ADDENDUM NO. 3

CITY OF ROLLA
TAXIWAY A RECONSTRUCTION AND TAXIWAY CONNECTOR REHABILITATION
at
ROLLA NATIONAL AIRPORT (VIH)
VICHY, MO

MoDOT Project # 23-056A-1

1. Sheet G004 – Summary of Approximate Quantities (Sheet 4 of 54)

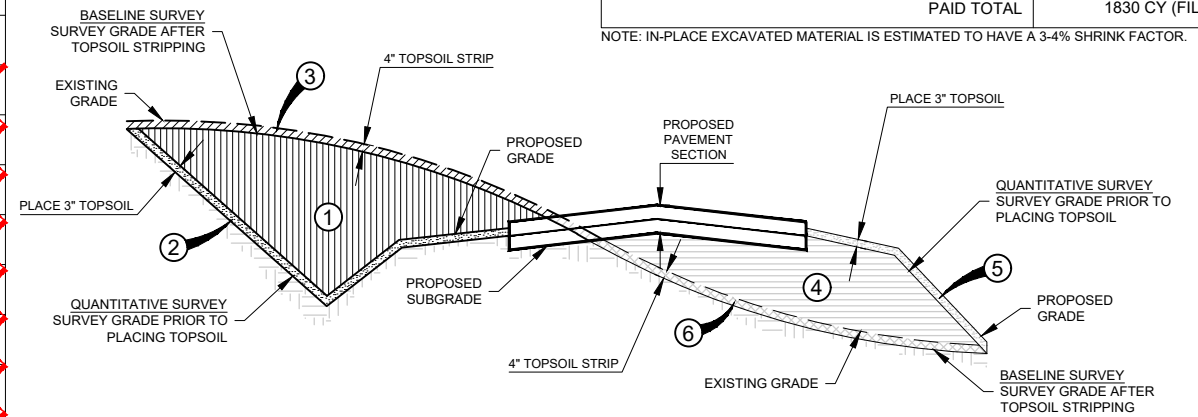
Revision: Updated earthwork summary table.

Justification: The earthwork was updated to reflect the accurate cut and fill quantities for the project. A note was also added to specify the shrink factor applied to the quantity calculation.

Revision: Updated Detail 1 Earthwork Calculations Detail (Excavation).

Justification: The detail was updated to reflect embankment, and whether items are paid or incidental to P-152a and P-152b.

AREA DESCRIPTION	CUT (CY)	FILL (CY)
SCHEDULE I - TAXIWAY A RECONSTRUCTION		
TAXIWAY A - SOUTH	450	200
TAXIWAY A - NORTH	290	1525
SCHEDULE I SUBTOTAL	740	1725
SCHEDULE II - TAXIWAY B REHABILITATION		
TAXIWAY B	0	0
SCHEDULE II SUBTOTAL	0	0
SCHEDULE III - TAXIWAY A UNDERDRAINS		
UNDERDRAINS	80	0
SCHEDULE III SUBTOTAL	80	0
PROJECT TOTAL	820	1725
PAID TOTAL	1830 CY (FILL)

NOTE: IN-PLACE EXCAVATED MATERIAL IS ESTIMATED TO HAVE A 3-4% SHRINK FACTOR.

- ① EXCAVATION INCIDENTAL TO P-152a EMBANKMENT IN-PLACE
- ② TOPSOIL (PLACED) INCIDENTAL TO ITEM T-905a TOPSOIL
- ③ TOPSOIL (STRIPPED) PAID AS T-905a TOPSOIL

- ④ EMBANKMENT PAID AS P-152a EMBANKMENT IN-PLACE AND P-152b OFFSITE BORROW MATERIAL
- ⑤ TOPSOIL (PLACED) INCIDENTAL TO ITEM T-905a TOPSOIL
- ⑥ TOPSOIL (STRIPPED) PAID AS T-905a TOPSOIL
